Explanation of Significant Differences

CORNHUSKER ARMY AMMUNITION PLANT (CHAAP)  
OPERABLE UNIT ONE

February 7, 1997

LOCATION OF MONITORING POINTS  
 DRAINAGE CANAL/SILVER CREEK  
 CORNHUSKER AAP INTERIM GROUNDWATER REMEDY

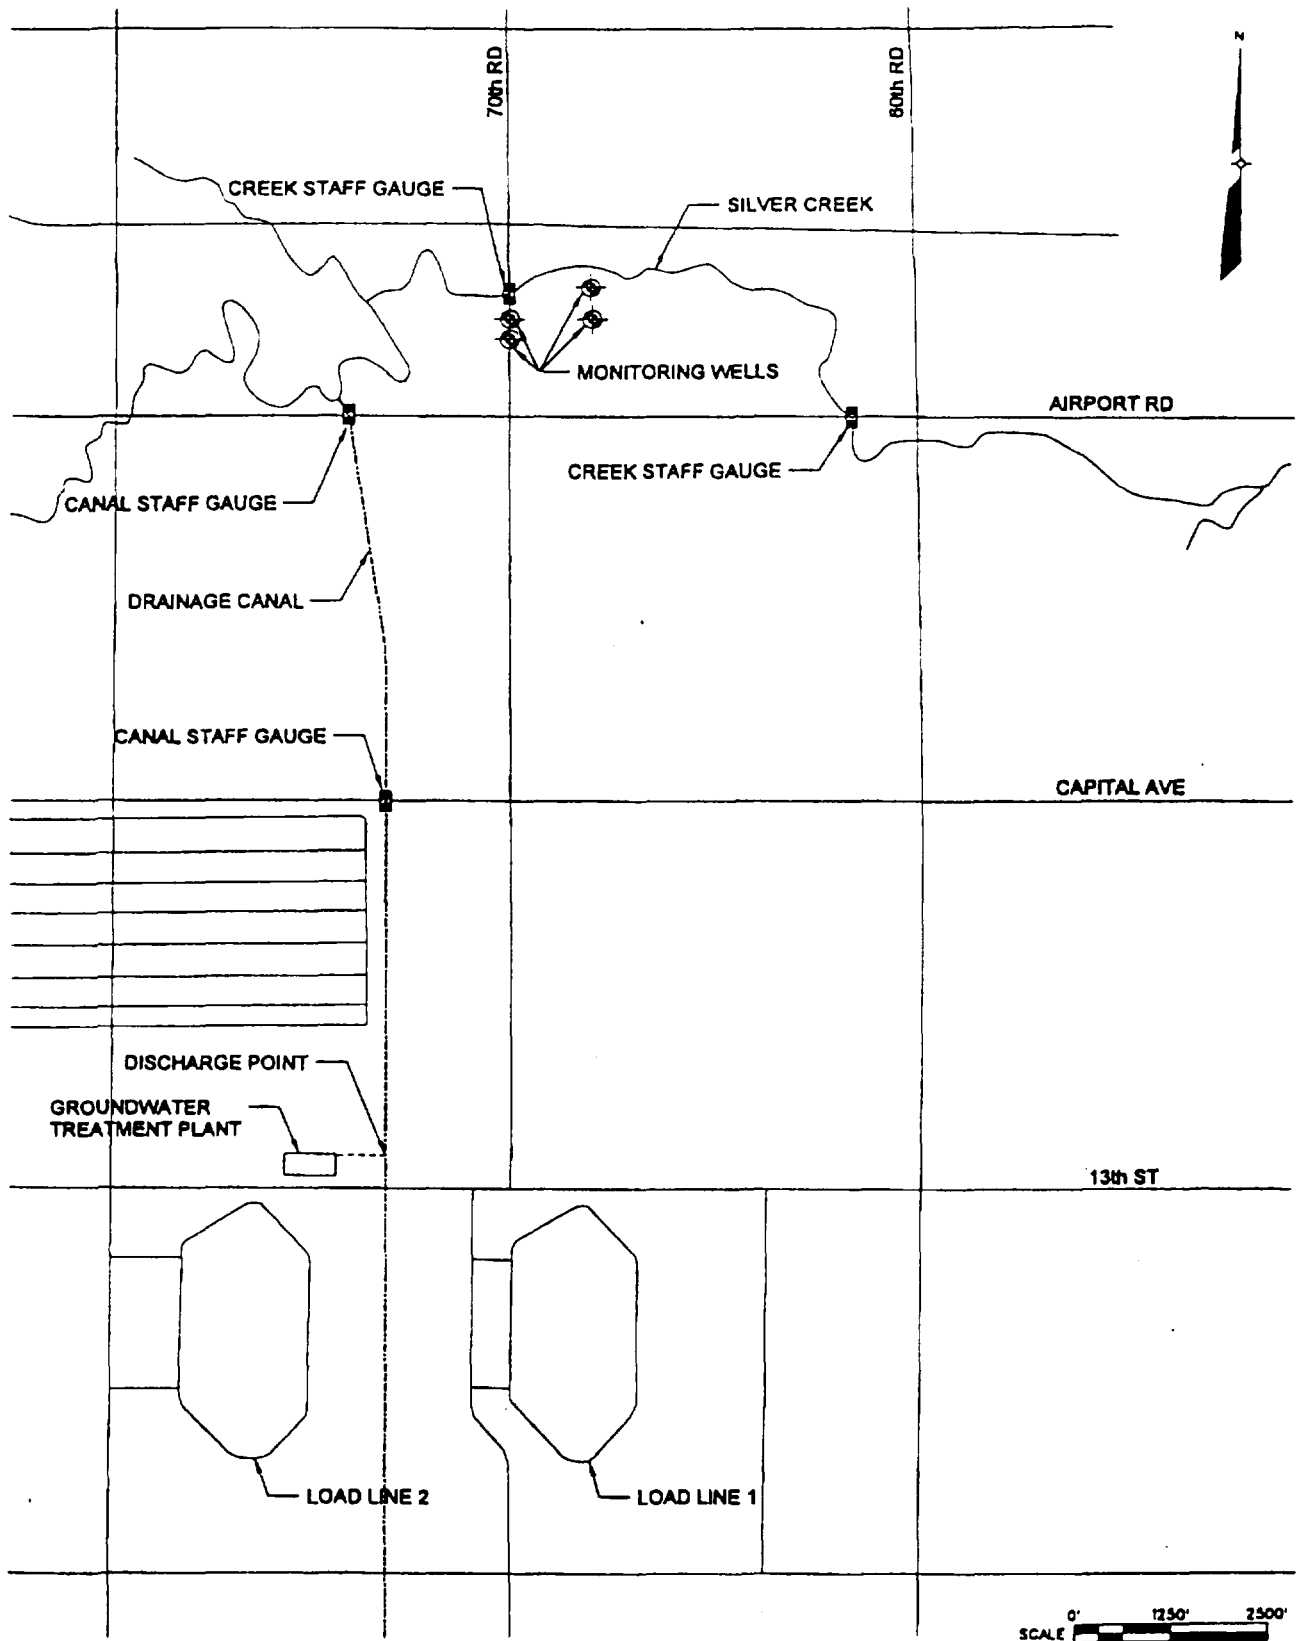
Under the phased approach, the Army proposes to begin on-site extraction and treatment as soon as possible. The treated water would be discharged to an existing

drainage canal located on CHAAP. The water in the canal would discharge to Silver Creek after traveling through CHAAP for about two miles. This proposal differs significantly from the earlier Silver Creek discharge proposal in two ways:

In addition to the modeling effort a monitoring program has been proposed to monitor the surface water flow in the creek, take visual observations and monitor groundwater levels along Silver Creek. Surface water flow measurements will be made twice per month for two years. Visual

observations will be recorded to include documenting distance of observable flow in the canal and Creek. These observations will be made during periods of little or no precipitation (when there is no flow upstream at the point where the Canal discharges into the Creek). This will provide data on infiltration rates through the drainage canal and Creek bed that can be used to refine the model predictions. Any ice buildup conditions in the winter will also be documented. If ice buildup is excessive the system will be temporarily shut-down.

LOCATION OF MONITORING POINTS  
DRAINAGE CANAL/SILVER CREEK  
CORNHUSKER AAP INTERIM GROUNDWATER REMEDY

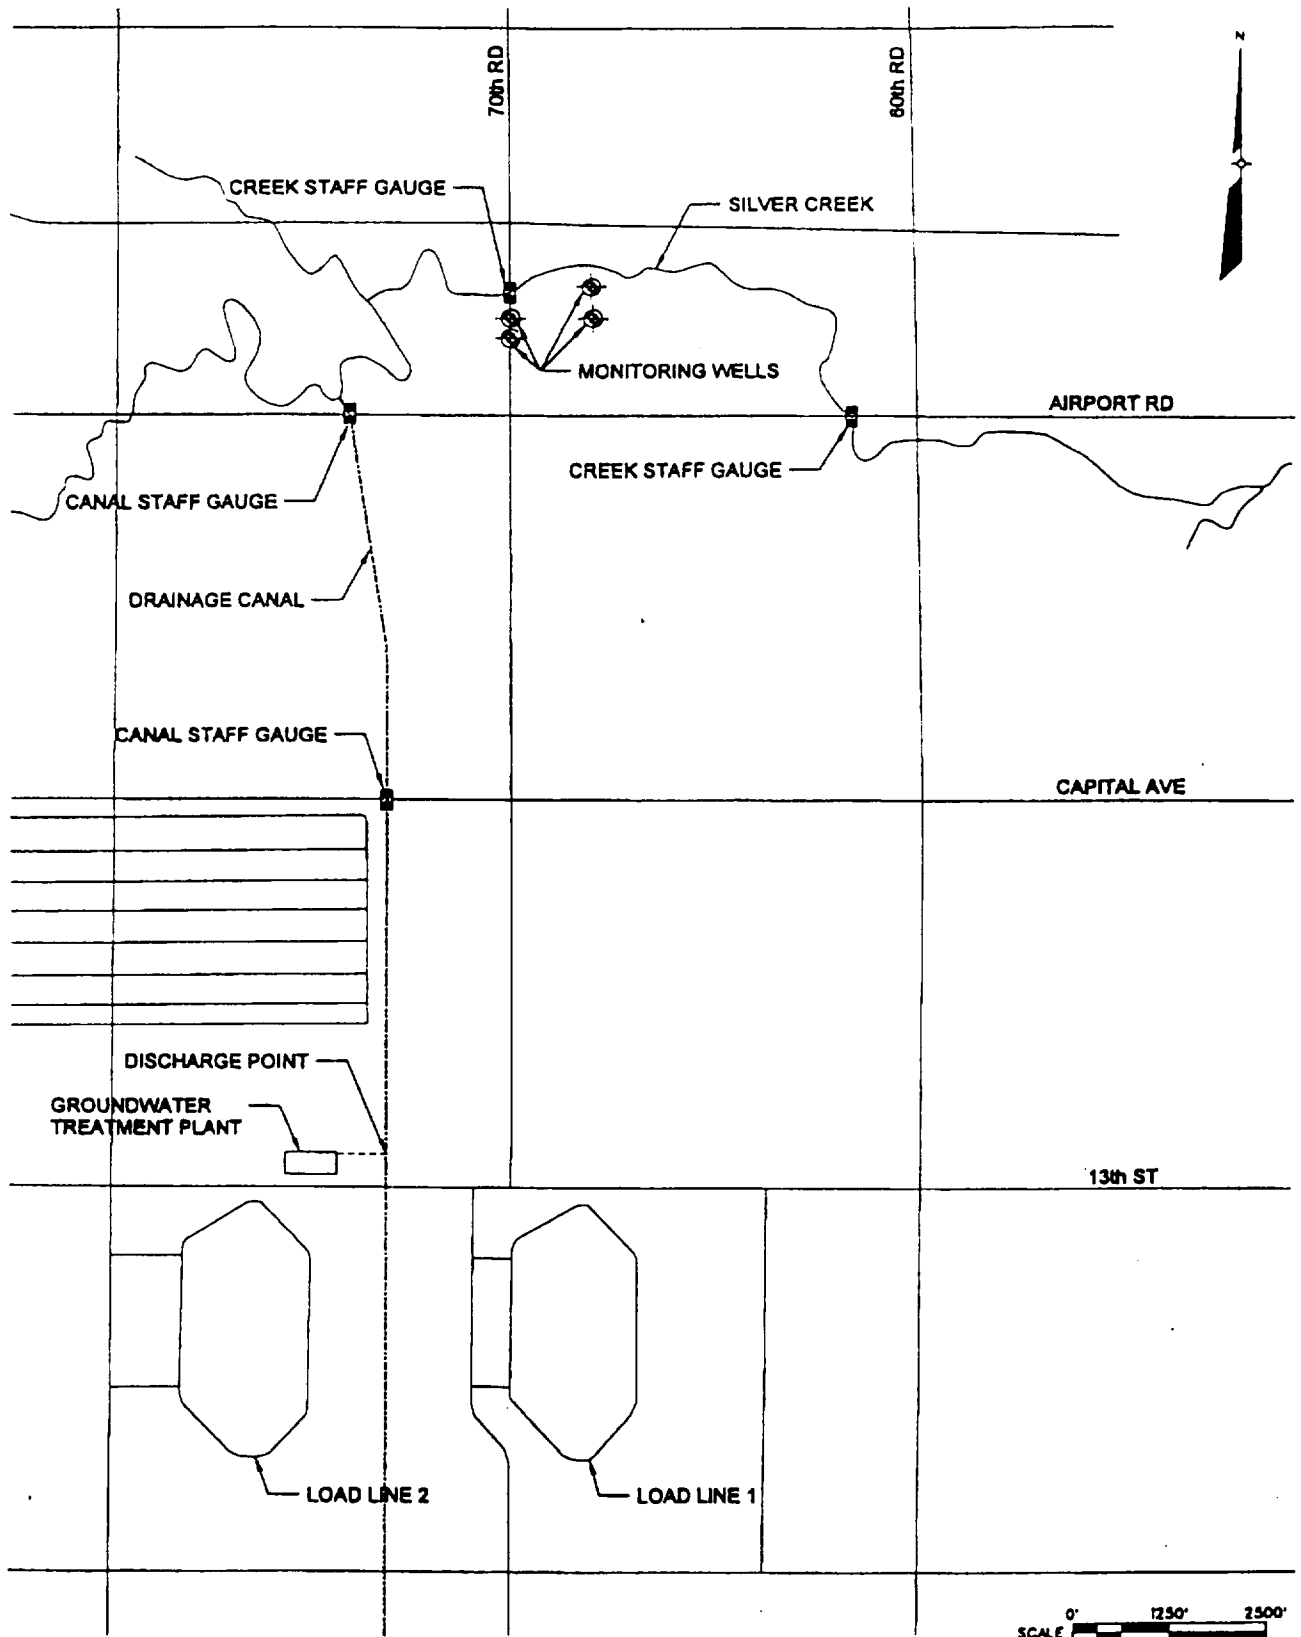
Under the phased approach, the Army proposes to begin on-site extraction and treatment as soon as possible. The treated water would be discharged to an existing

drainage canal located on CHAAP. The water in the canal would discharge to Silver Creek after traveling through CHAAP for about two miles. This proposal differs significantly from the earlier Silver Creek discharge proposal in two ways:

In addition to the modeling effort a monitoring program has been proposed to monitor the surface water flow in the creek, take visual observations and monitor groundwater levels along Silver Creek. Surface water flow measurements will be made twice per month for two years. Visual

observations will be recorded to include documenting distance of observable flow in the canal and Creek. These observations will be made during periods of little or no precipitation (when there is no flow upstream at the point where the Canal discharges into the Creek). This will provide data on infiltration rates through the drainage canal and Creek bed that can be used to refine the model predictions. Any ice buildup conditions in the winter will also be documented. If ice buildup is excessive the system will be temporarily shut-down.
